**SUNDRY NOTICES AND REPORTS ON WELLS**  
**Do not use this form for proposals to drill or to re-enter an abandoned well. Use Form 3160-3 (APD) for such proposals.**

8. Well Name and No.  
Macho Fed Com. #11

**Macho Fed Com 11  
30-005-61649  
Vanguard Operating, LLC  
October 16, 2018  
Conditions of Approval**

AFTER P+A

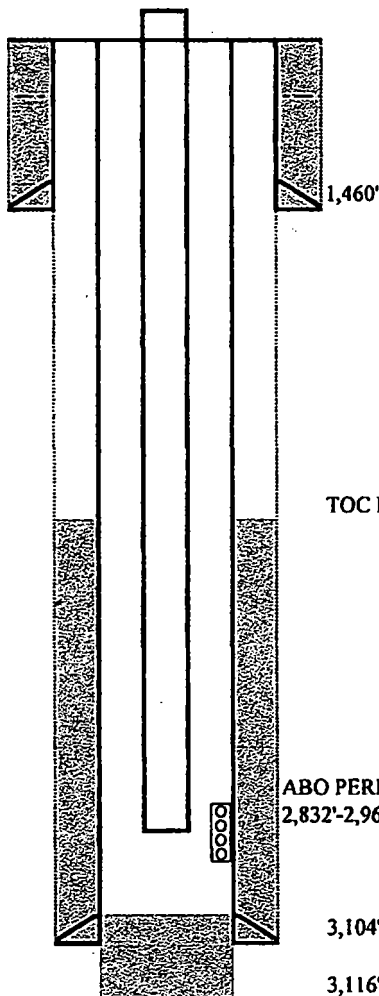
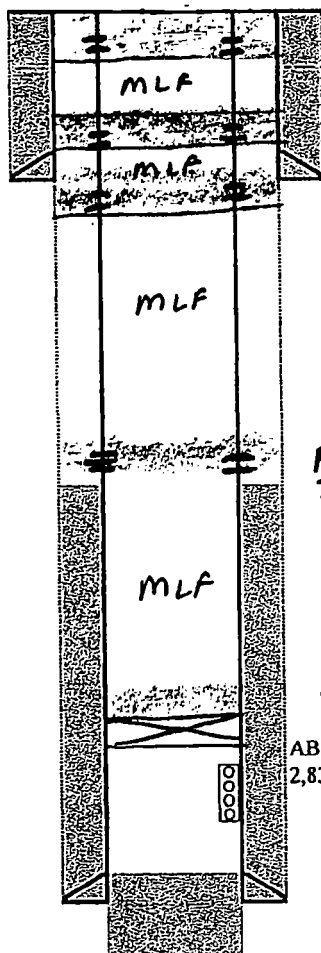
PERF @ 100' CIRC CMT TO SURF ALL STRINGS  
WDC VERIFY CMT AT SURF

PERF 796' SQZ 50 SX'S CM T  
1,460' 796'-696'  
PERF 1510' SQZ 50 SX'S CM T  
1510'-1410'

PERF 2130' S R2 50 SX'S CMT  
2130'-2030'

SPOT 20 545CMT 2782'-2682'  
CIBPC 2782'

- 1. Operator shall place CIBP 50'-100' above top most perf and place 25 sx of Class C cement on top to seal the Abo Formation. WOC and TAG.**
- 2. Operator shall perf at 2,130' and squeeze cement as proposed. Operator shall place a Class C cement plug from 2,130'-2,030' as proposed. WOC and TAG.**

- 3. Operator shall perf at 1,510' and squeeze cement as proposed. Operator shall place a Class C cement plug from 1,510'-1,340' as proposed to seal the 8-5/8" shoe. WOC and TAG.**

- 4. Operator shall perf at 796' and squeeze cement as proposed. Operator shall place a Class C cement plug from 796'-696' as proposed. WOC and TAG.**
- 5. Operator shall perf at 600' and squeeze cement as proposed. Operator shall place a Class C cement plug from 600'-434' as proposed to seal the Glorietta Formation. WOC and TAG.**

- 6. Operator shall perf and squeeze at 100'. Operator shall place a Class C cement plug from 100' to surface as proposed.**
- 7. See Attached for general plugging stipulations.**
